FILE P. I. No. 0000931, Whitfield County
NHS00-0000-00(931)
I-75 @ SR 3/US 41 Rocky Face Exit-
Interchange Reconstruction Phase II

SUBJECT APPROVED REVISED PROJECT CONCEPT REPORT

REVISED PROJECT CONCEPT REPORT

NHS00-0000-00(931),
INTERCHANGE RECONSTRUCTION I-75 @ U.S. 41/ S.R. 3 (ROCKY FACE)
WHITFIELD COUNTY
P.I. No. 0000931

REVISED CONCEPT REPORT LAYOUT
I-75 /US41 /SR 3 INTERCHANGE
PROJECT NO. NHS-0000-00(931)

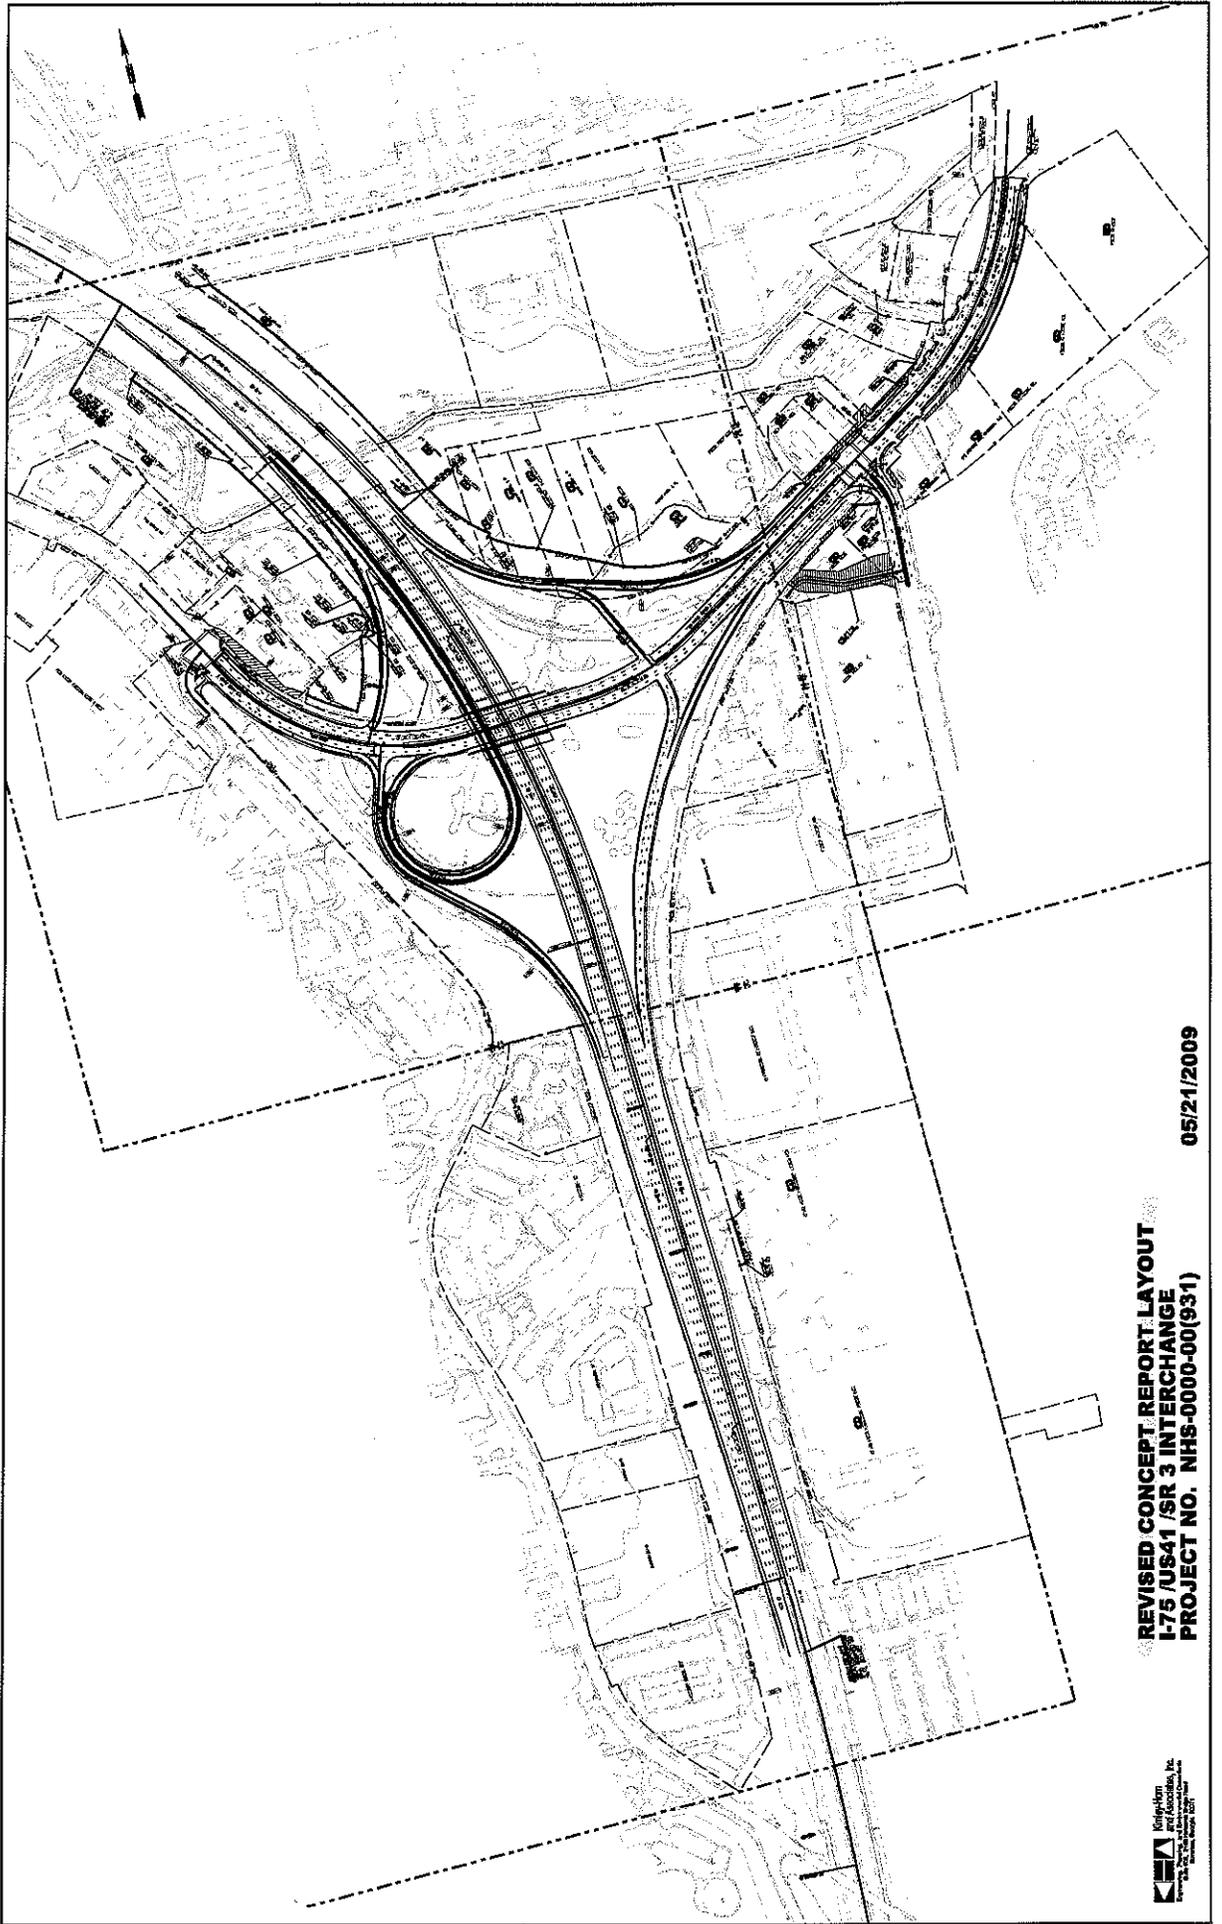
- The I-75 typical section will be revised. The Approved Concept Report includes a provision for a future lane along I-75 to the outside. The existing I-75 median is 40' wide and is barrier separated. The Revised Concept proposes to accommodate the future lane to the inside of I-75 utilizing the existing median.

- The collector distributor adjacent to I-75 northbound will not be constructed. The Approved Concept Report included a barrier separated collector distributor auxiliary lane to run parallel to I-75 northbound and southbound. The northbound collector distributor led to the loop ramp in the northeast quadrant of the interchange and provides the I-75 northbound to US 41/ SR 3 westbound movement. The Revised Concept Report provides for the I-75 northbound to US 41/ SR 3 westbound to be included as dual left turn lanes in the southeast quadrant of the intersection. A signalized intersection is proposed.

- The US 41/ SR 3 typical section will be revised. The Approved Concept Report depicts US 41/ SR 3 in the area of the I-75 bridge as a six lane facility with a 3 ½ foot median and dual left turn lanes immediately after the bridge to provide access to I-75 northbound and southbound. Numerous design exceptions that were required due to the existing I-75 bridge configuration with respect to US 41/ SR 3. These design exceptions were for horizontal and vertical clearance. The I-75 bridge will be reconstructed as a single span bridge with MSE walls at the end bents. This configuration will negate the need for design exceptions with respect to US 41/ SR 3. The revised typical section will consist of a six lane roadway with urban shoulder and a 20' raised median. The 20' median will accommodate single left turn lanes to access I-75 northbound and southbound. The outside shoulder will be 18'.
